SEWAGE DISPOSAL SYSTEM

MARYLAND STATE DEPARTMENT OF HEALTH

SUBDIVISION Florence Estates ROAD 2125 Cabin Branch LOT 17, Section 2

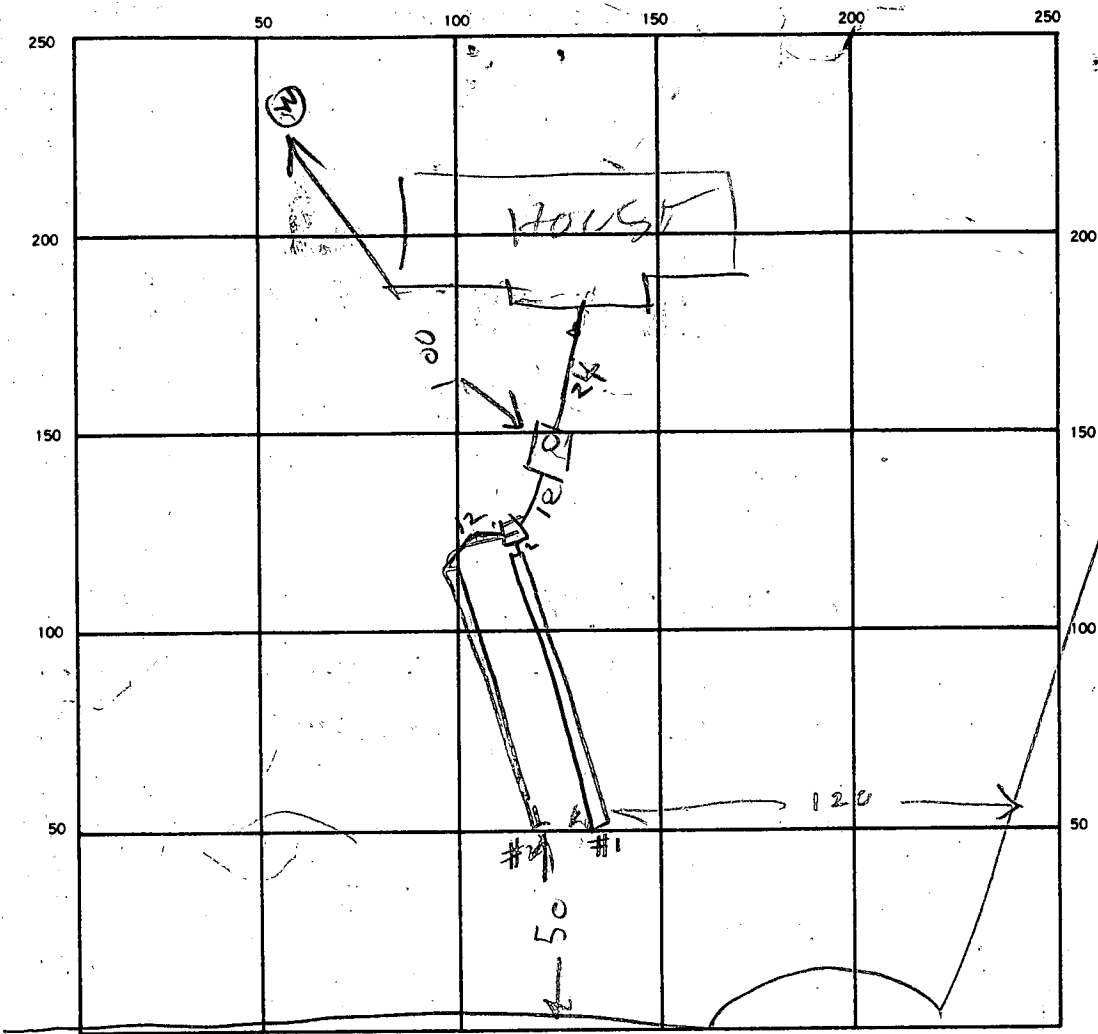
REMARKS 11/20/87 SNOW TURN LOCATION OK ADD STONE & PIPE TO TRENCHES RH

11/20/87 STONE ADDED BUT NOT HOOKED

TO HOUSE CALL FOR INSPECTION OF

HOUSE HOOK UP RH

12/31/87 HOUSE SEWER OK RH
